## Product Change Notice

([PC-WRP-A001A/E])

**Change Description:** Unification of a JEDEC tray and a embossed carrier tape for LQFP package

Tray Pocket cross section

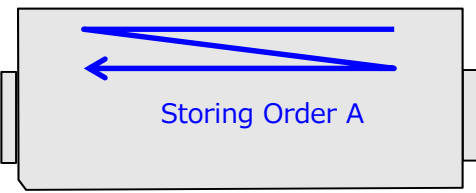
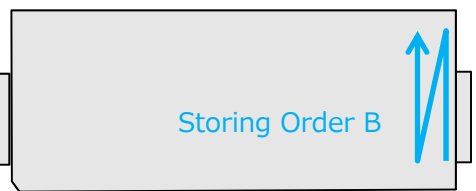
[1-2] Unification of the JEDEC Tray for LQFP Package.

The products shipped by an old model tray shall be changed to a new model tray. A JEDEC specified size (External size, Pocket Pitch, etc.) shall not be changed by this unification, but the seat position may be differed between old and new. The products has already shipped by the new model shall not be changed the tray model. There are a plural pocket shapes (Shape of the pocket hole) at the new tray.

Applied Package	Applied Products	Before		After	
		Old Tray Model	PKG Seat position(mm)	New Tray Model	PKG seat position(mm)
LQFP 7x7	Ref. to APPENDIX 2-A	L196-56	2.0	LQFP7x7x1.4	2.0
LQFP 10x10	Ref. to APPENDIX 2-B	L196-49	2.0	LQFP10x10x1.4	1.5
LQFP 12x12	Ref. to APPENDIX 2-C	JHB-121214	1.5	LQFP12x12x1.4	2.0
LQFP 14x14	Ref. to APPENDIX 2-D	L196-05	1.5	TQFP14x14x1.4	2.0
LQFP 16x16	Ref. to APPENDIX 2-E	PTB83C	1.8	LQFP16x16x1.4	1.8
LQFP 20x20	Ref. to APPENDIX 2-F	L196-65A	2.0	LQFP20x20x1.4	1.6
LQFP 24x24	Ref. to APPENDIX 2-G	L196-06A	1.5	LQFP24x24x1.4	1.5

[1-3] Unification of the storing order of IC in the JEDEC Tray

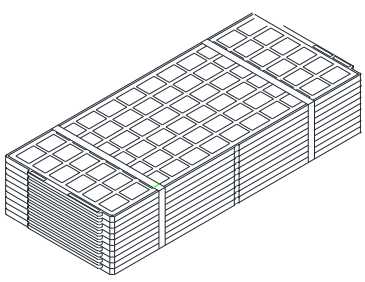
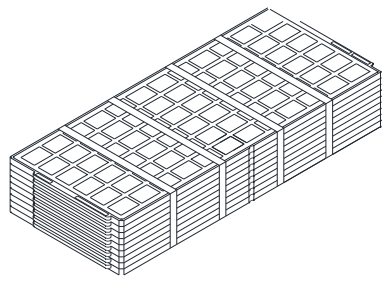
The package storing order to JEDEC tray shall be unified to one direction (Storing Order C) from a plural direction.

Item	Before	After
Storing Order A in the tray		
Applicable products	Ref to APPENDIX 3-A

Item	Before	After
Storing Order B in the tray		
Applicable products	Ref to APPENDIX 3-B
